# intel® Technical Advisory

TA-750-1

## Installation of the Intel® Xeon™ Processor 4-pin fan to the Intel® Server Board SE7520AF2 3-pin fan headers

Figure 1. 3-pin and 4-pin heatsink fan connectors

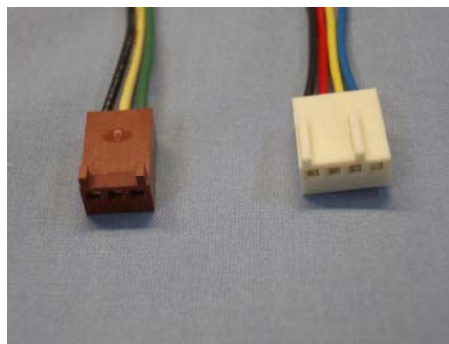
The 64-bit Intel® Xeon™ processor with 800MHz system bus and 2MB of L2 cache is shipping with a new heatsink fan which has a 4-pin connector (refer to figure 1 below). Processor heatsink fans are included only on the active boxed processor SKUs, passive boxed processor SKUs will continue to ship a heatsink with no fan. When integrating the Intel® Server Board SE7520AF2 into the Intel® Server Chassis SC5300, the passive version (no fan) of the Intel® Xeon™ processor must be used. For instances where the server board is integrated into third party chassis the active heatsink solution may be required to meet the processor cooling requirements.

The four signals routed to the new fan connector include the ground signal, fan power signal, fan tachometer signal and fan Pulse Width Modulation (PWM) signal. The latter is a new signal being added to control the fan speed for improved acoustics based on processor thermal demands.

Figure 2. Processor 1 Fan Header

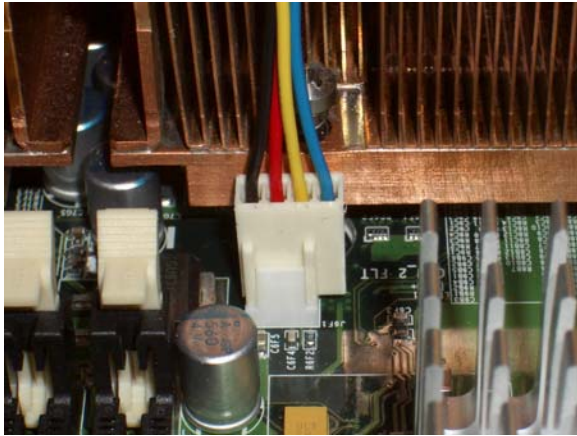
The Intel® Server Board SE7520AF2 which supports the active and passive processors solutions enables active processor support via two 3-pin processor fan headers. In addition to continuing to support 3-pin fans, the server board will accommodate plugging the new 4-pin connector onto the 3-pin fan header with the PWM signal left unconnected (refer to Figures 2 and 3 below). Leaving the PWM signal unconnected will result in the processor heatsink fan running

Intel does not plan to modify the Intel® Server Board SE7520AF2 to support the PWM signal of the 4-pin heatsink fan connector of this new processor. In order to install the 4-pin heatsink fan connectors onto the board's 3-pin processor fan headers, install the fan connector such that the pins 1-3 are inserted onto the header and pin 4 (PWM signal – blue wire) extends off the edge of the fan header (refer to Figures 2 and 3 above). Leaving the PWM signal unconnected will result in the processor heatsink fan running under thermistor control (functionality identical to the current 3-wire heatsink fan). No other adverse effects are expected on the performance of the processor or server baseboard.
